**06-002/14 - MULTI-MODEL - UNUSUAL NOISE WHEN STARTING TO MOVE VEHICLE WHILE STEERING WHEEL IS TURNED TO FULL LEFT POSITION**

<b>Subject:</b> UNUSUAL NOISE WHEN STARTING TO MOVE VEHICLE WHILE STEERING WHEEL IS TURNED TO FULL LEFT POSITION	<b>Bulletin No:</b> 06-002/14
	<b>Last Issued:</b> 07/29/2014

- This bulletin supersedes the previous bulletin 06-002/13, issued on 10/09/13. The APPLICABLE MODEL(S)/VINS, DESCRIPTION, REPAIR PROCEDURE, PART(S) and WARRANTY INFORMATION have been revised.
- Changes are noted below in Red beside the change bar.

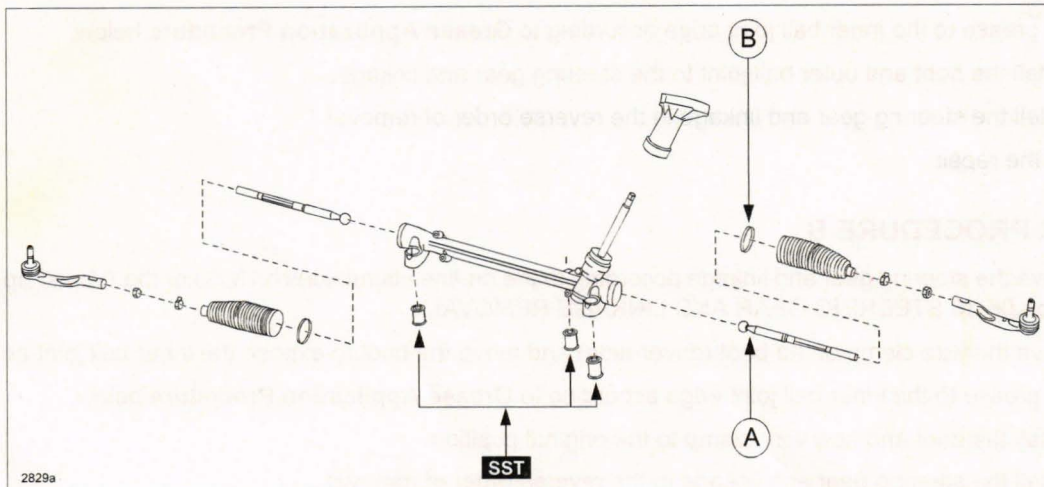
The noise is caused when the edge of the left side inner ball joint (A) gets stuck with the steering gear housing.

The following modifications have been made to eliminate the noise:

1. The shape of the inner ball joint edge has been changed.
2. Grease has been applied to the inner ball joint edge.

**Grease Application Procedure:**

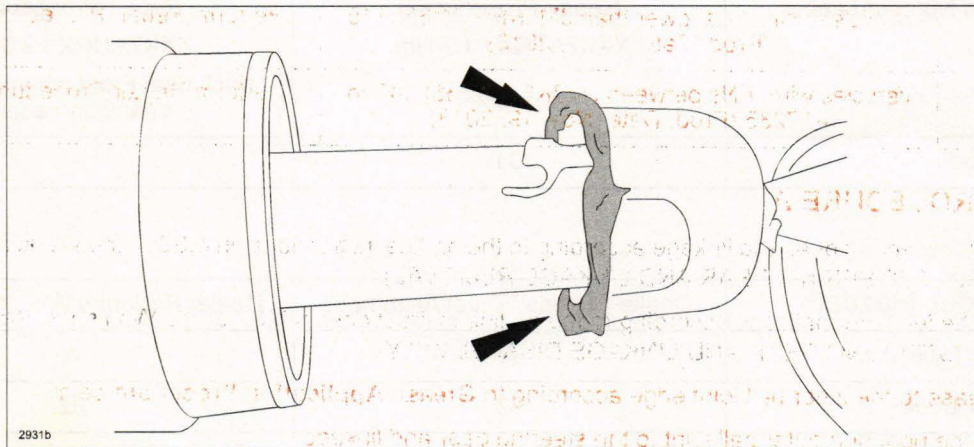
1. Squeeze approx. 1cc of grease out of the tube onto your finger.

2. Apply the grease all the way around the inner ball joint edge.
